## MEMORANDUM

**Date:** ~~September 24, 2020~~ **Revised 10/29/2020**  
**To:** Dan Hennessey, P.E. (WGI)  
**CC:** Sangeeta Jain, AICP  
Philip Utubor, EIT  
**Reference:** Howard Lane MFAM – TIA Final Memo (C14-2020-0059)

### **Summary of the Transportation Impact Analysis (TIA):**

Figure 1 - Site Location and Driveways

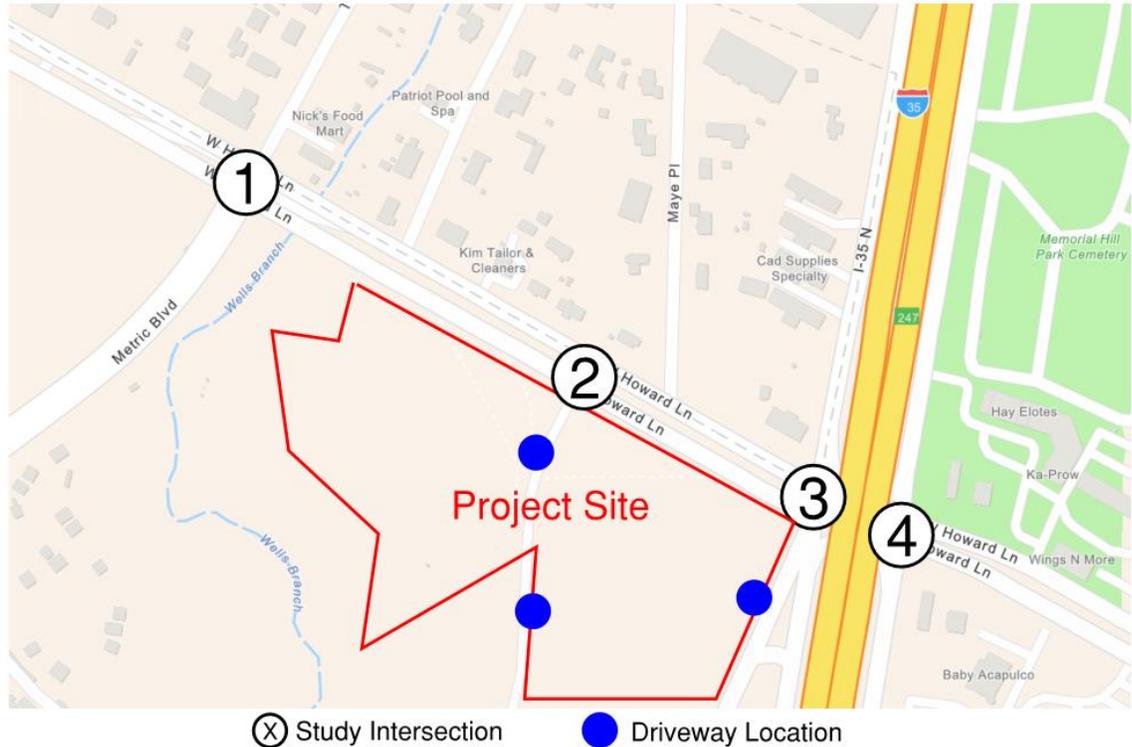
The site is currently vacant and is undeveloped. The proposed multifamily development would be built on both the west and east sides of the John B Connolly High School driveway. The west portion of the development would consist of 136 dwelling units (DU) and the two sites on the east side of the driveway would consist of a 186 DU and 36 DU multifamily development, respectively.

The proposed development is intending to use four driveways for site access. The proposed site will access the high school driveway at three (3) locations as well as one access onto North Lamar Blvd as detailed below:

- Driveway 1 (Private) - Full access along John B Connally HS driveway to the west
- Driveway 2 (Private) - Full access along John B Connally HS driveway to the east
- Driveway 3 (Private) - Full access along John B Connally HS driveway to the west
- Driveway 4 (Public) - Exit-only access onto North Lamar Blvd

Figure 2 – Pedestrian Gap Analysis

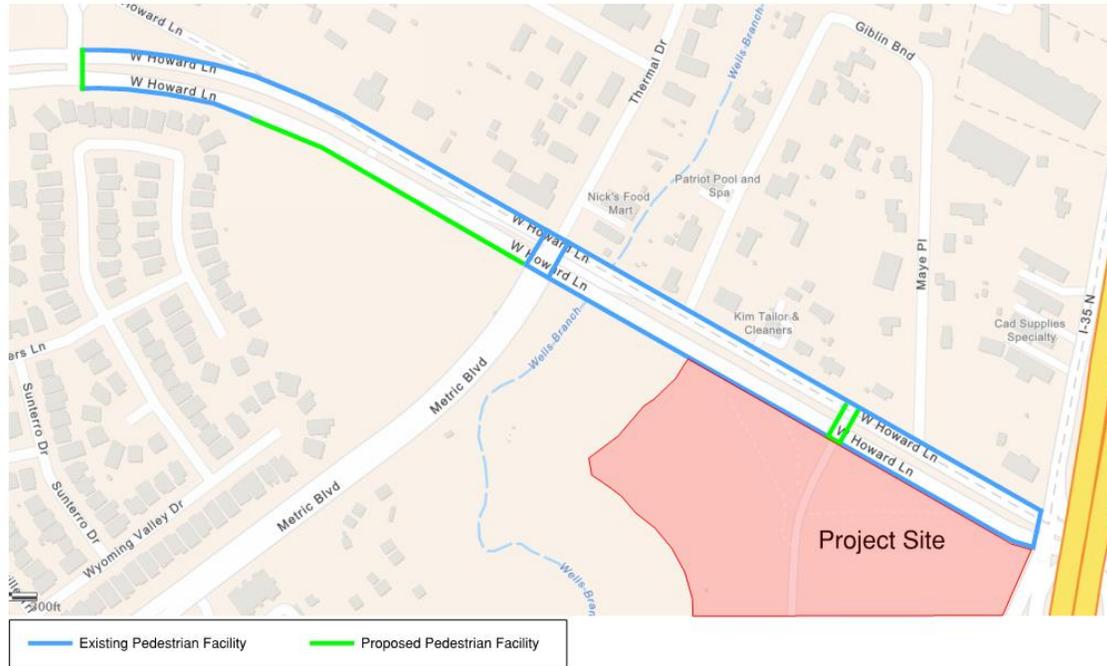
Currently, there exists infrastructure for pedestrians and bicyclists in the area with gaps in connectivity. The analysis further identified many active modes infrastructure needs that would help to meet the goals of Austin Strategic Mobility Plan (ASMP) and fill in gaps to provide seamless connectivity for pedestrians and bicyclists. Pedestrian infrastructure improvements between IH 35 and Scofield Ridge Parkway were identified as needs in the area based on City identified plans and studies.

As part of the proposed site construction, the applicant shall pay toward bicycle and pedestrian improvements as shown in the TDM portion of the TIA, as well as shown in Figure 2 and in Table 2.
